EVERSTEAD  
SHOP DRAWINGS/SUBMITTAL REVIEW

JOB No.	3016791
DESCRIPTION	SUMMIT HOMES - STONEY CREEK #95
JOB ADDRESS	1708 SW HIGHTOWN DR
CITY	LEE'S SUMMIT, MO 64082
DESIGNER	TODD W MOORE
DATE	12/14/2021

ROOF  
TRUSS LAYOUT

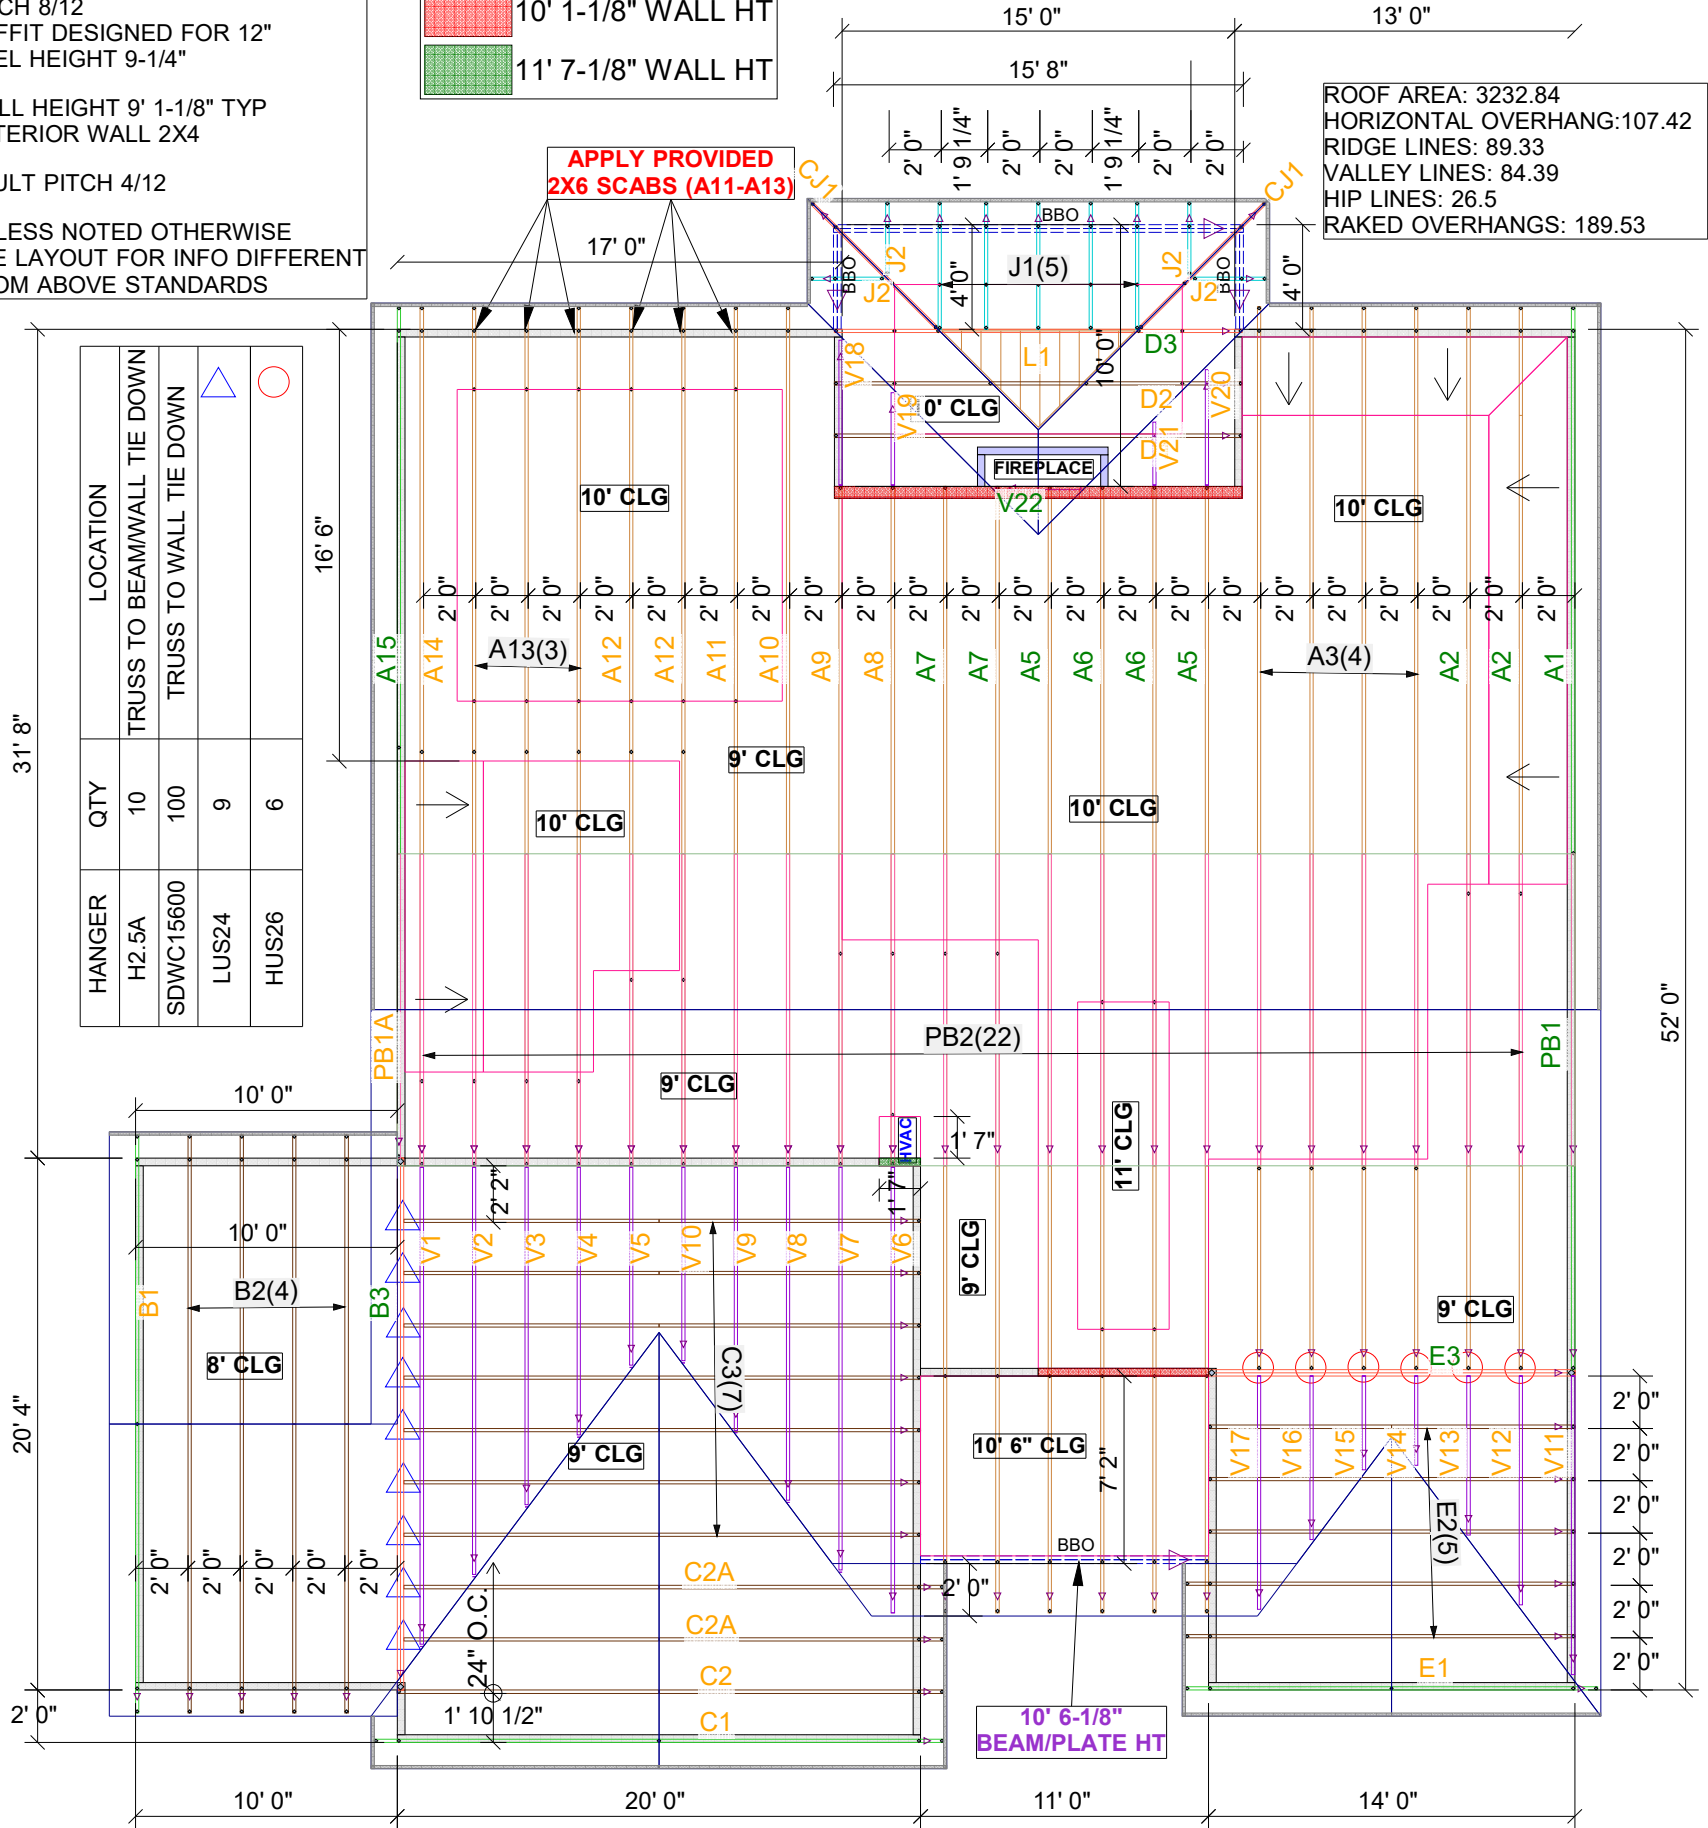
STATUS:  
**APPROVED**  
12/29/2021
